INDESIT company

MBA3841CIBS

F029552

n1030063: Upper hinge modified on Ariston Opera-60 fridge-freezers with Display

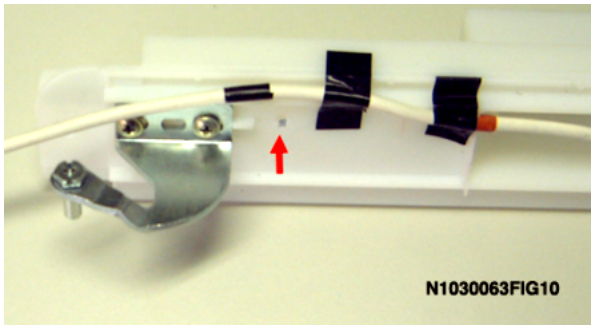
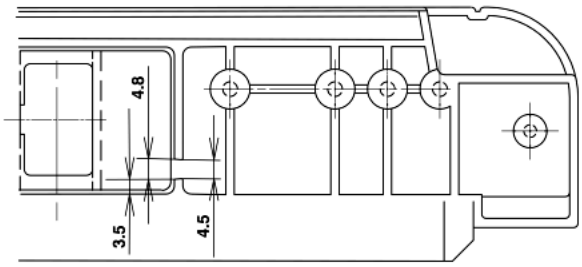
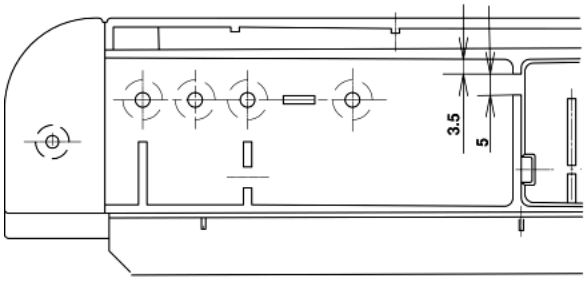
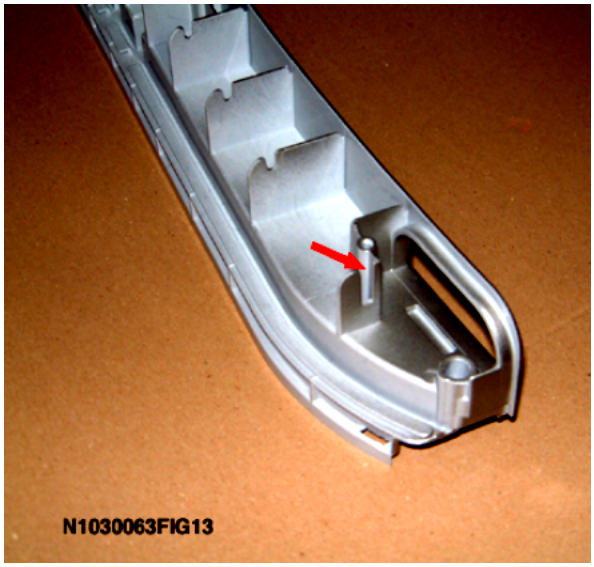
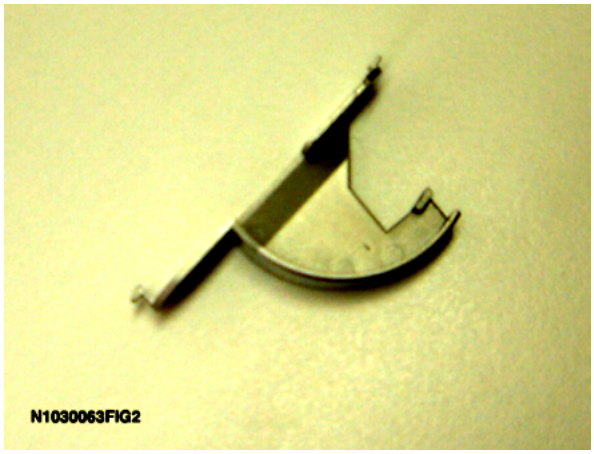
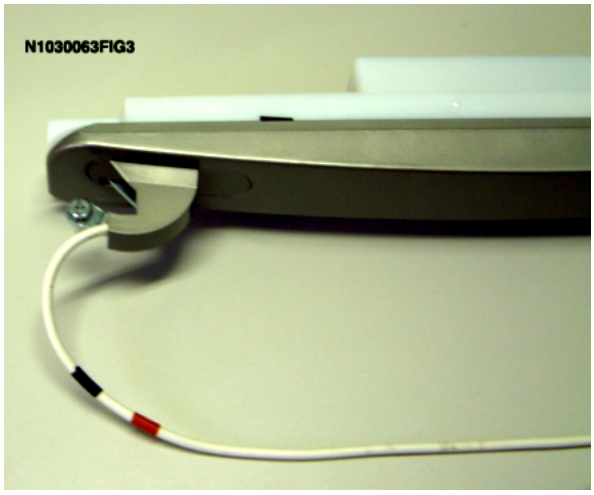
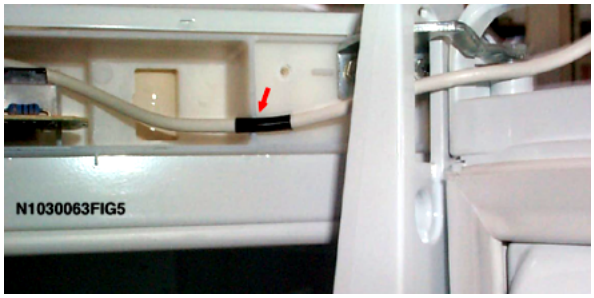
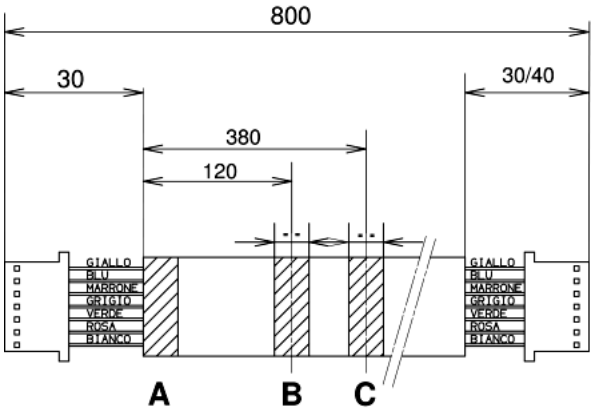
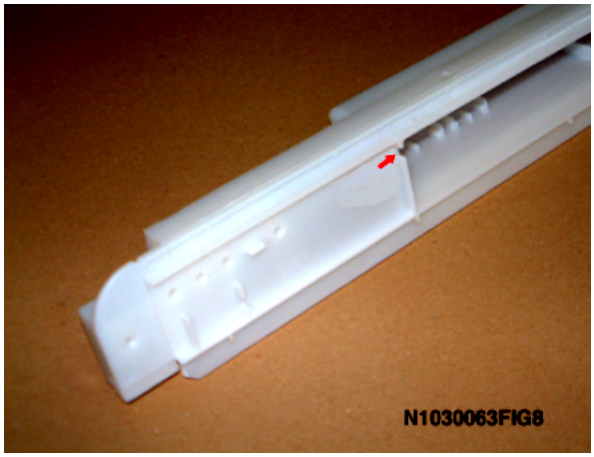
In October 2003 (serial no. 31028.0001) the Melano factory replaced the upper plastic hinge assembly on the Opera-60 fridge-freezers with display, in order to improve the fridge door support and prevent the cable connecting the two cards (power and display) from being damaged.
The new assembly provides for use of the upper hinge, chromed, with relative pin, and modified hinge cover (see fig.1-2).
The hinge assembly is reversible by rotating the single parts 180° and then refitting the pin (see fig.3).
Another two other tape reference marks (now three) have been placed on the card connection cable for correct installation on the panel base and fridge door in order to have the right flexibility during rotation. When the door is open the cable must never be strained.
The reference marks on the cable refer to right hand opening (see fig.4):
-Reference mark (A) indicates which end must be connected to the panel power card.

-Reference mark (B) must be fitted in the seat obtained on the panel base (see fig.5).
-Reference mark (C) must be fitted in the seat obtained on the right side of the door, in the hinge area (see fig.6).

If the door opens on the left, these reference marks on the cable must be modified as shown in fig.7.
(A) has not been changed, whereas (B) has become 120 mm and (C) 380 mm. Colours other than black can be used so as not to confuse them.
Also, reference mark (B) must be fitted in the seat obtained on the panel (see fig.8), whereas the (C) must be fixed in the second tab from the left (see fig.9).
In the left-hand opening version, when tightening the fixing screw make sure the cable is not crushed by the panel. To avoid this, the cable should be fixed with adhesive tape to the vertical and horizontal ribbing, so that it passes inside the groove, thus avoiding the hole (see fig.10).

On the right hand bottom part of the cabinet panel base (hinge area) there is a slot (4.5/4.8) to be used for correct positioning of the cable (see fig.11-12).
Even the first cable seat on the upper head of the fridge door (hinge area, right side) has been modified, from 6x10 mm to 4x20 mm. This prevents the cable from moving when the door is opened/closed (see fig.13).
The fridge doors for models with display, currently managed as replacements, do not have the modification shown in fig.13; in this case the width of the cable (reference area C) must be increased using more adhesive tape until it is blocked in the first support seat (6x10 mm).

On premodification models, the new hinge assembly can only be used if the panel base is modified (see fig.11-12). On the left side the 5 mm slot is already present; whereas, for the fridge door, the width of the cable must be increased on models with right-hand opening (reference area C) as described above.
If the door opens on the left, proceed as described above (fig.7- 8-9-10).

New parts

081644 - UPPER HINGE(M8) RH-LH CHROMED
075565 - UPPER HINGE PIN M8X3 (18+2.5)
097861 - UPPER HINGE COVER RH-LH ALUMINIUM
097862 - UPPER HINGE COVER RH-LH WHITE
097872 - PANEL/DISPLAY WIRING (3-MARKS)

Parts replaced

081846 - UPPER HINGE (M8) RH WHITE (WIRING)
081847 - UPPER HINGE (M8) LH WHITE (WIRING)
081844 - PANEL WIRING (DISPLAY) KIT
081848 - UPPER HINGE COVER WHITE
082013 - UPPER HINGE COVER ALUMINIUM-METAL

n1030082: Power card alternative on full no frost and static 400 litre combined fridge

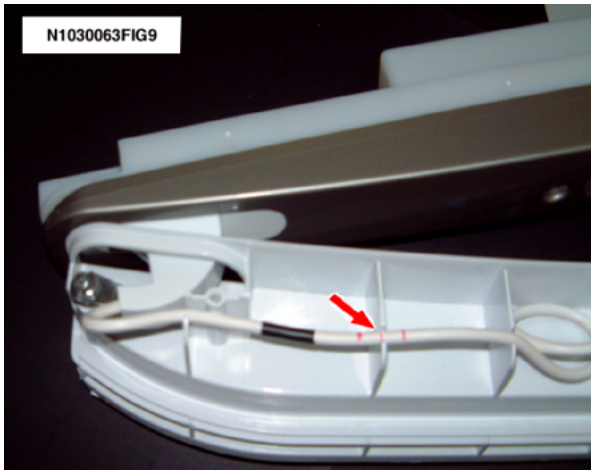
Since July 2004, the Melano factory has been using new power cards on full no frost and static 400 litre combined fridge-

freezers, as an alternative to the previous cards.
These cards are interchangeable, but have different codes (PN).

Given below are the modified codes:

Models MBA3841C- 3842C MBA4041C-4042C (IT-EU markets)
081843 - 16200044419 = Magnetek 4080.02/Grey (first version)
081843 - 16200099900 = Magnetek 4302.02/Grey (second version)

Models MBA40D2NF/NFE (IT-EU markets)
095711 - 16200069505 = Magnetek 4087.02/Yellow (first version)
095711 - 16200100000 = Magnetek 4304.02/Yellow (second version)

n1030089: Production of Ariston Opera-60 fridge-freezers in Polar White colour (Melano)

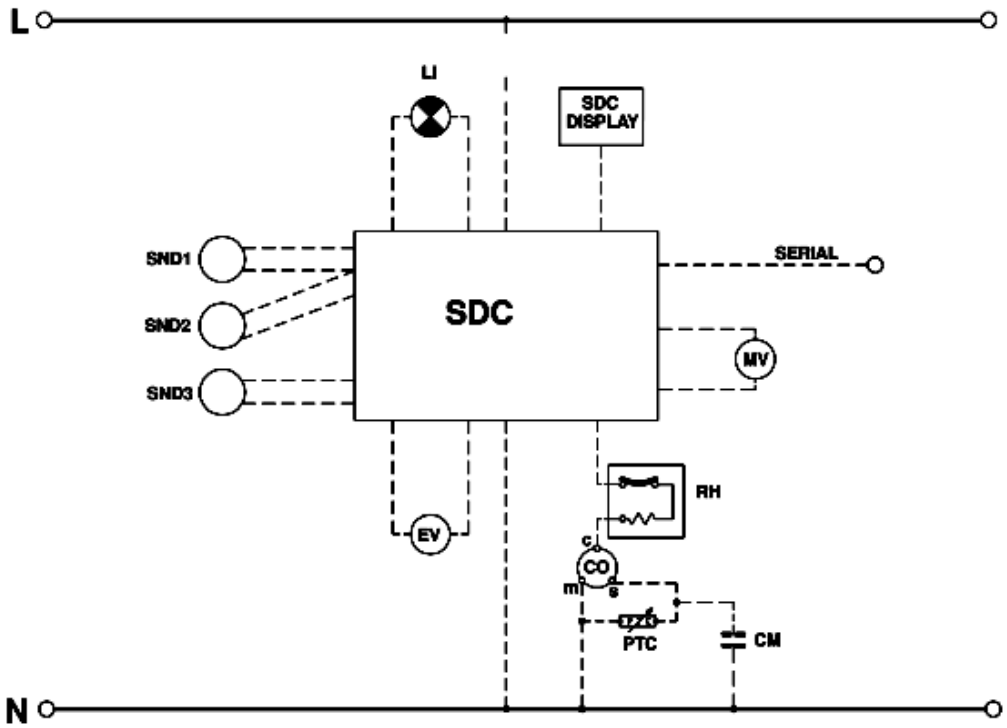
In January 2005, the Melano factory started producing Ariston Opera-60 fridge-freezers in the new "polar white" colour in place of white-27.
The industrial code of these models has changed (see example), whereas the initials (MB3811) and commercial code (25183) have remained the same.

E.g. 93251830001 = MB3811 white-27
E.g. 93251830101= MB3811 polar white

The colour change affects the following structural and external appearance parts only:

-Body, body control panel, plinth.
-Central hinge and hinge covers, hole covers.
-Doors, seals, handles, control panel, bushes.
-Knobs, control panel button covers.

All internal accessories (racks, profiles, drawers, etc.) and door accessories (door shelves, egg trays, boxes, etc.) have remained the same.
NB- When you order a spare part, please pay attention to the industrial code.
Given below is the list of Polar White models:
